Docket Item # 9 & 10
BAR CASE # 2011-0105 &
2011-0106

BAR Meeting
June 15, 2011

ISSUE: Permit to Demolish/Encapsulate and Addition

LOCATION: 713 South Lee Street

Figure 4. Existing rear (west) elevation with areas to be demolished.

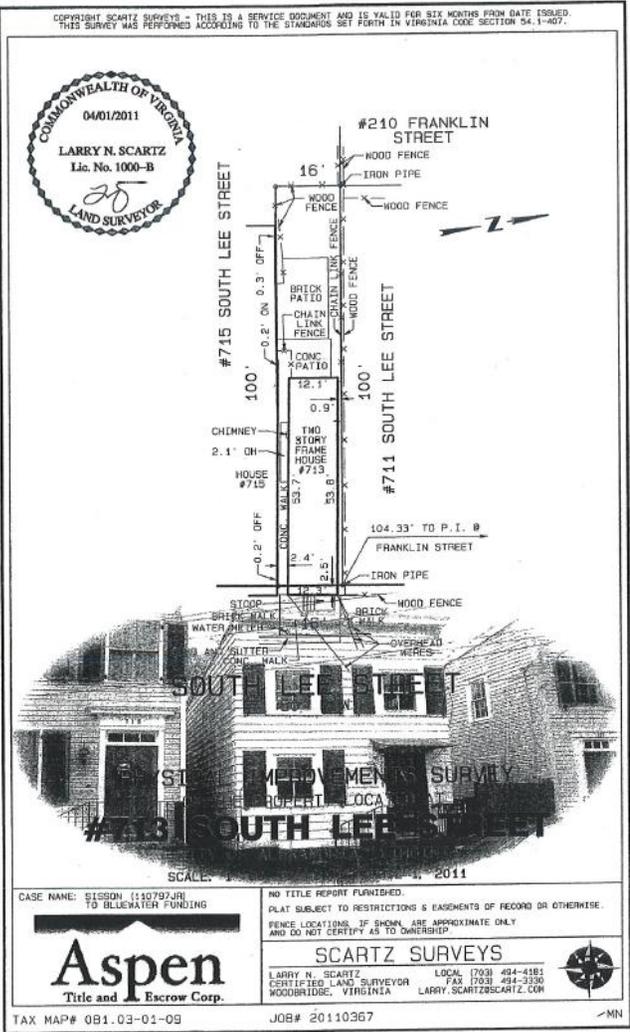
- Demolish the existing one-story rear addition in its entirety.
- Demolish/encapsulate the rear portion of the side (south) elevation.
- Demolish/encapsulate second story portion of the rear (west) elevation.
- Demolish rear portion of the existing roof.
- Remove existing metal canopy at front door.
